# FPUD JOB NO. 3095 – SMRCUP Construction

## ADDENDUM D

June 26, 2019

This Addendum "D" includes clarifications and/or changes to the Contract Documents for the Fallbrook Public Utilities District, **Santa Margarita River Conjunctive Use Project Construction**

SHEET NO.  
**123 OF 387**

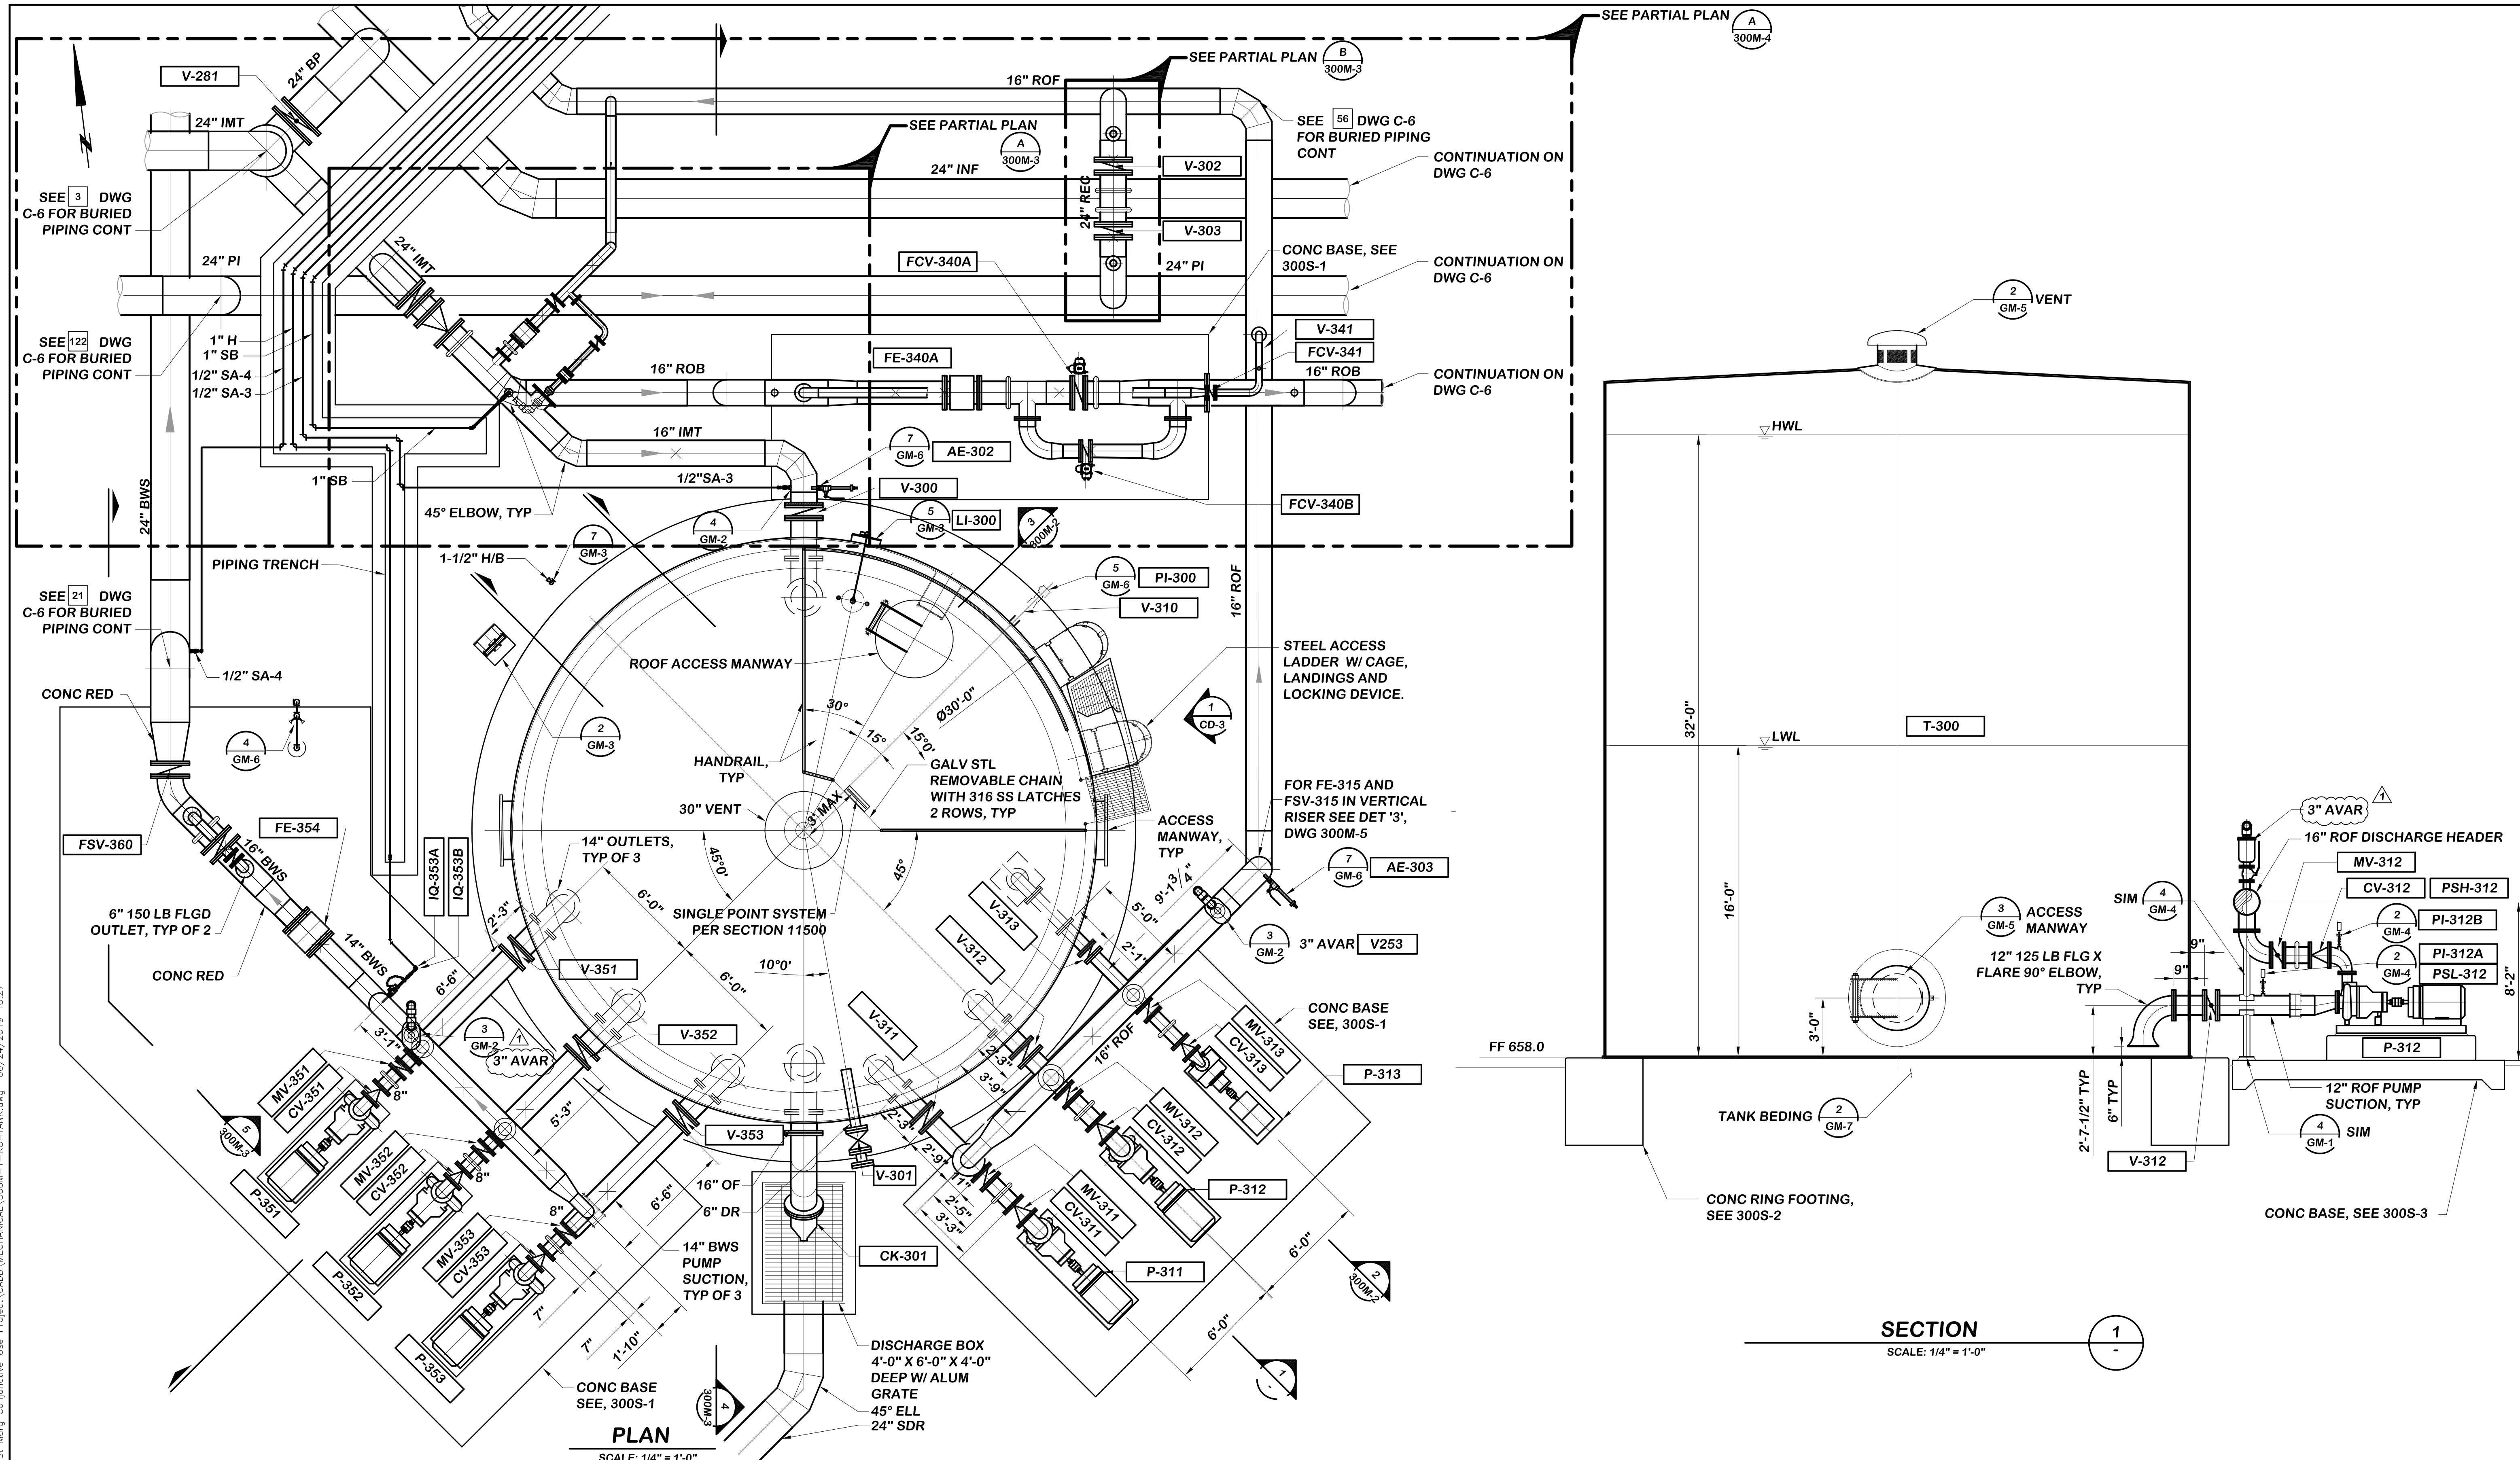
84	In section 1 and 2 on drawing sheet 200M-4 there is a buried 6" airline shown that doesn't match the P&IDs. It appears that the entire airline should be installed above grade and that maybe this buried portion should be removed. Please confirm	<b>Make the following modifications to the Contract Documents.</b> There is no buried air line. See revised Sheet 200M-4.
85	Section 11500, Paragraph 2.6 A.1., requires tank roof to be knuckled, but drawings do not show a knuckle. Please clarify.	Tank roof to be knuckled per Section 11500.
86	Section 11500, Paragraph 3.4 D., requires lapped tank roof plates to be seal welded, but does not address if roof plates need to be welded to roof support rafters. Please confirm roof plate does not need to be welded to rafters.	Roof plates shall be seal welded to support rafters.
87	P&ID Sheet No. 373 details a Sample Pump SA-8 drawing off of the PW pipeline. That pump is not included in the Sample Pump schedule in Specification Section 11303. Please advise if this pump is to be included in this project.	<b>Make the following modifications to the Contract Documents.</b> SPECIFICATION SECTION 11303 REGENERATIVE TURBINE PUMPS <b>DELETE Table under Item 2.1.A and REPLACE it with the following</b> Sample Pump Area 500 Sample Line SA-5 Pump Tag P-351, Sample Line SA-6 Pump Tag P-352, Sample Line SA-7 Pump Tag P-353. Sample Line SA-8 flows by gravity.

108	Reference drawing no. 200M-3 and 200M-4, 6" Air Line at the Surface Wash Air Compressors. Drawing 200M-3 indicates an Expansion Joint coming off of the compressors, while drawing 200M-4 indicates these to be flexible couplings. Please clarify if these should be expansion joints or flexible couplings.	<b>Make the following modifications to the Contract Documents:</b> The joint is an expansion joint. See revised Sheet 200M-4.

DRAWING NO. <b>300M-2</b>
SHEET NO. <b>127 OF 387</b>
CLIENT JOB NO. <b>2744</b>

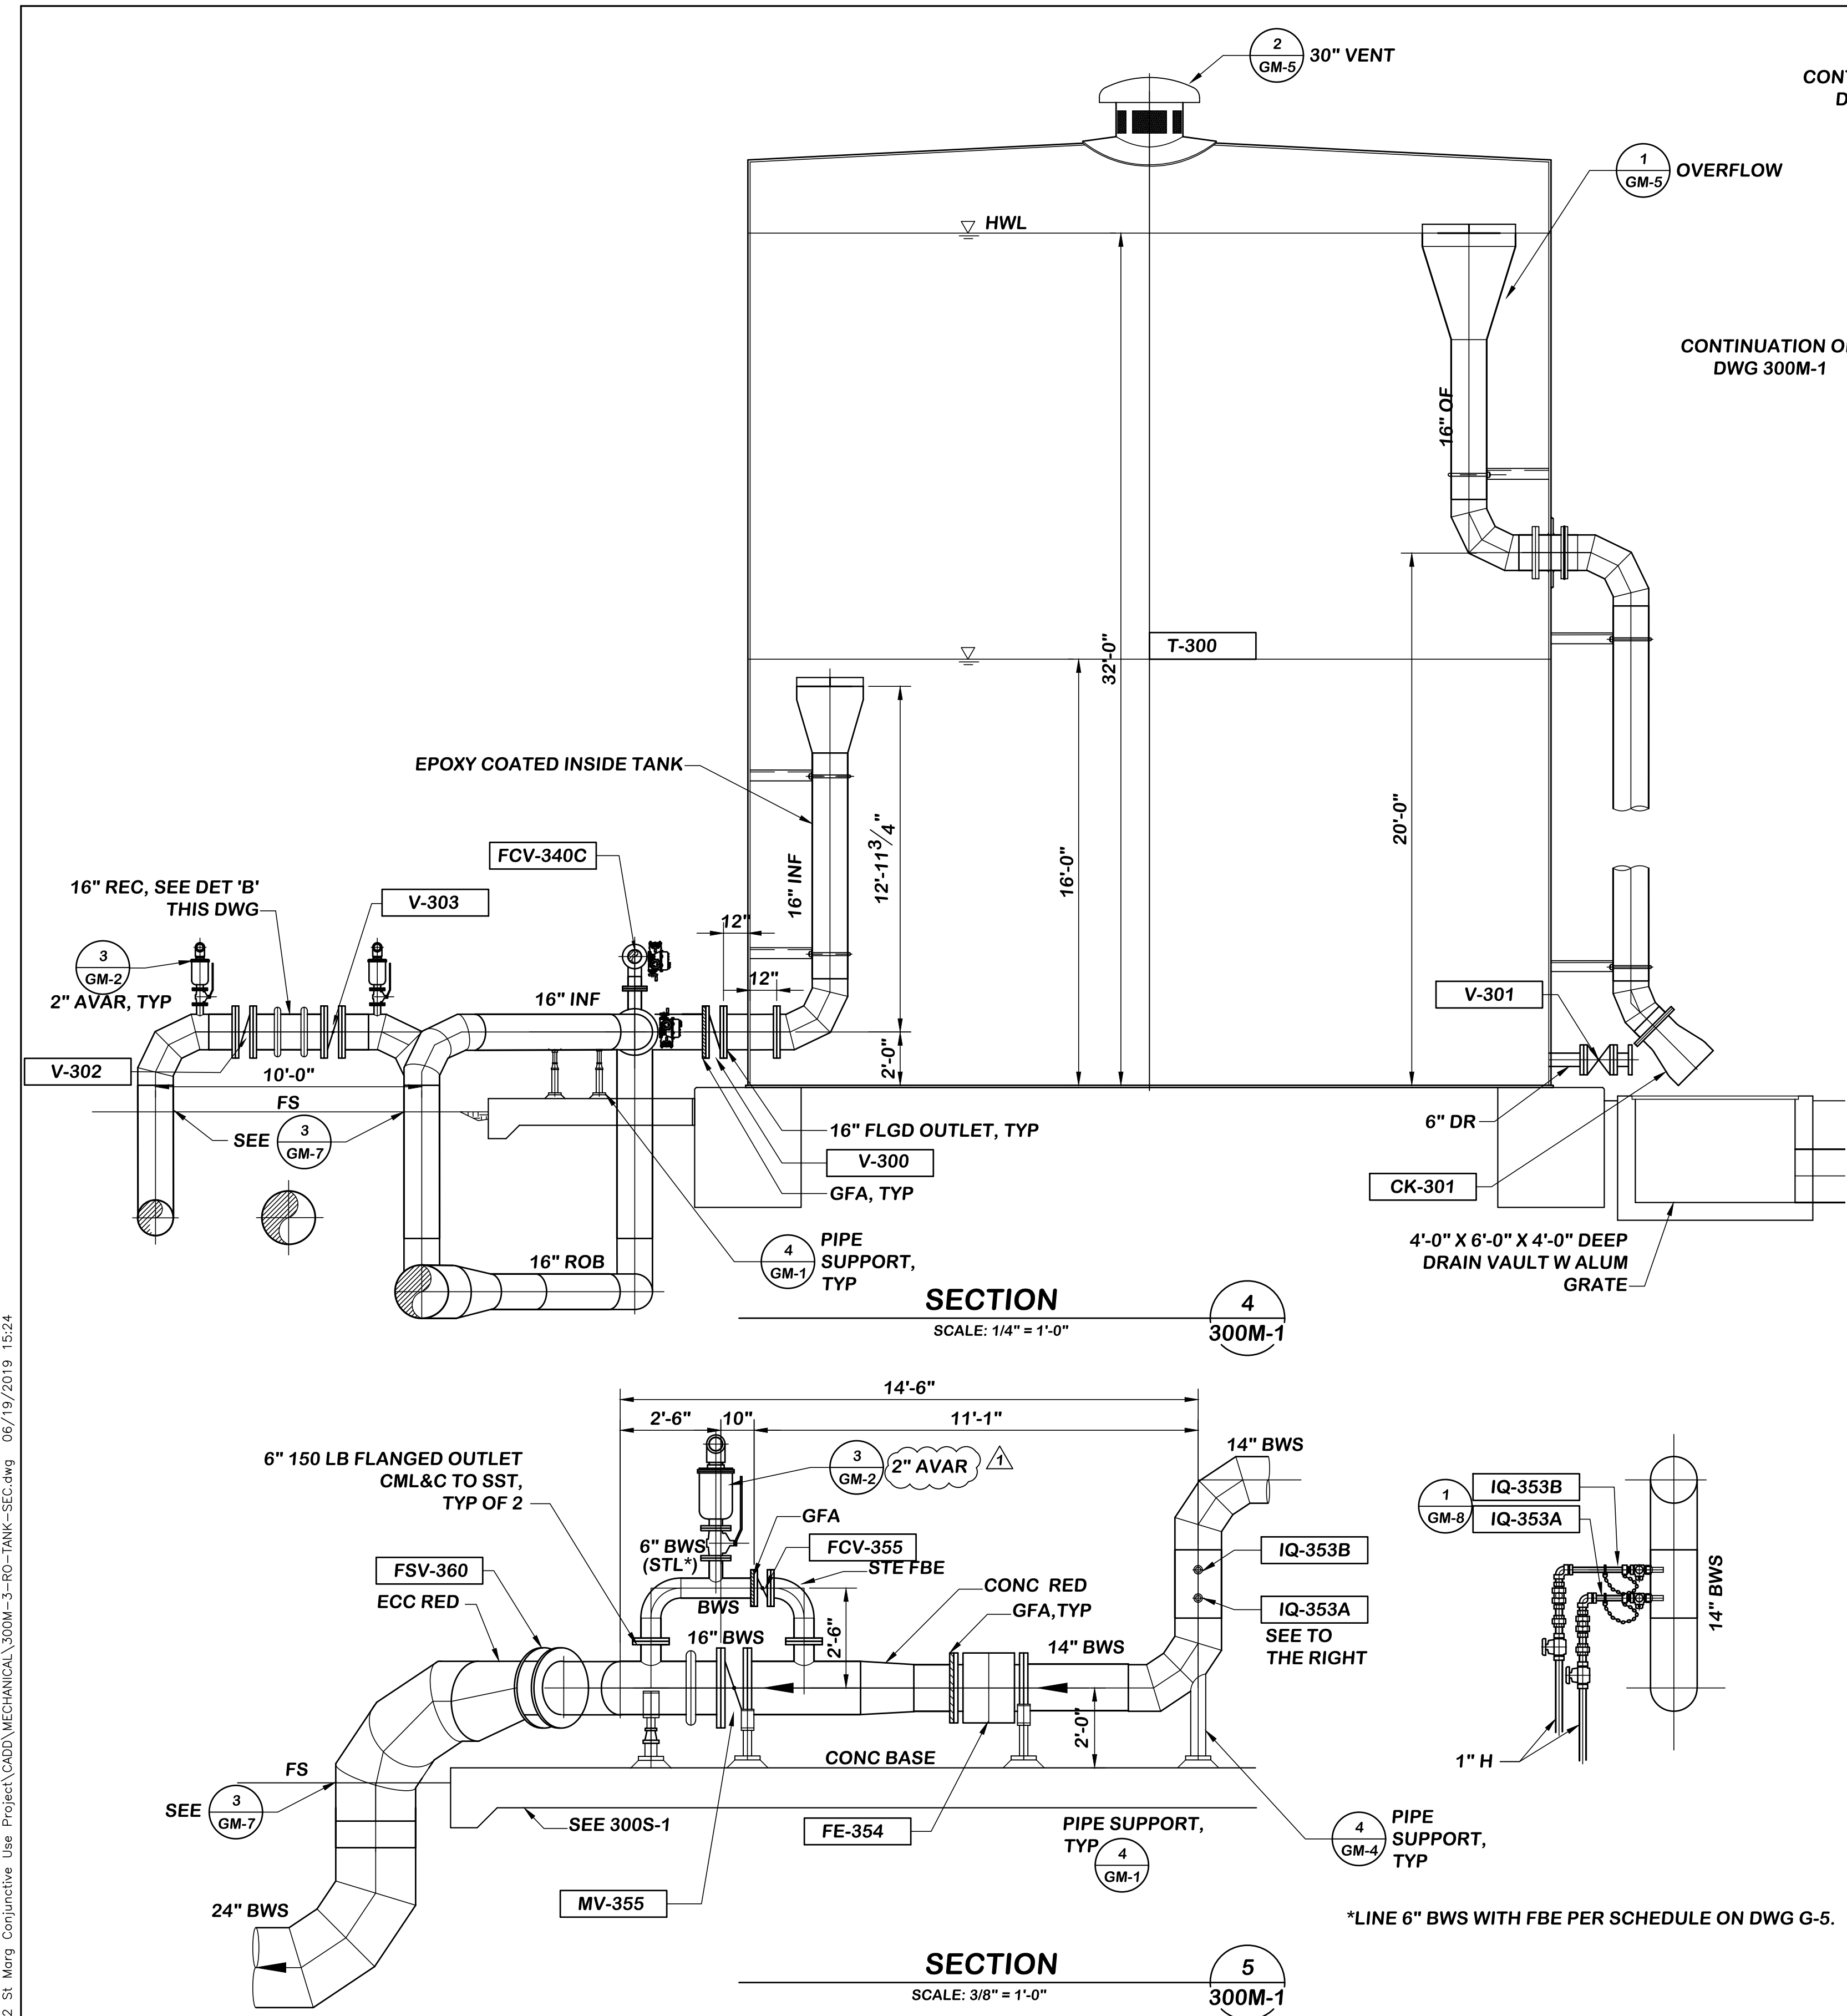
211	Valve SPEC Reference No. for Valve Tag No. V-870 as "None*" listed in the Partial Valve List included with Specification Section 15100 Valves (General) is not enough information.	Clarified. See expanded valve schedule included by addendum.
212	Valve SPEC Reference No. for Valve Tag No. V-884 as this information is not included in Specification Section 15000 Piping Components as directed in the Partial Valve List included with Specification Section 15100 Valves (General).	Clarified. See expanded valve schedule included by addendum.
213	Plan View on Contract Drawing 300M-1 indicates a 3" AVAR V253 on the 16" ROF Discharge from Pumps P311, P312 and P313. Section 1 indicates this as being a 4" AVAR. Contract Drawing 300M-1 indicates this as being ARV-315. Neither V-253 or ARV-315 is listed in the Partial Valve List included with Specification Section 15100 Valves (General). Please confirm that V253 on 300M-1 should be ARV-315 and provide the Valve SPEC Reference No., Size (in), Actuator Type, Actuator Designation, Pressure Class and Valve Type.	Air Relief Valves on discharge line for Pumps 311, 312 and 313 are 3", valve type V253. See revised sheet 300M-1 and 300M-2.
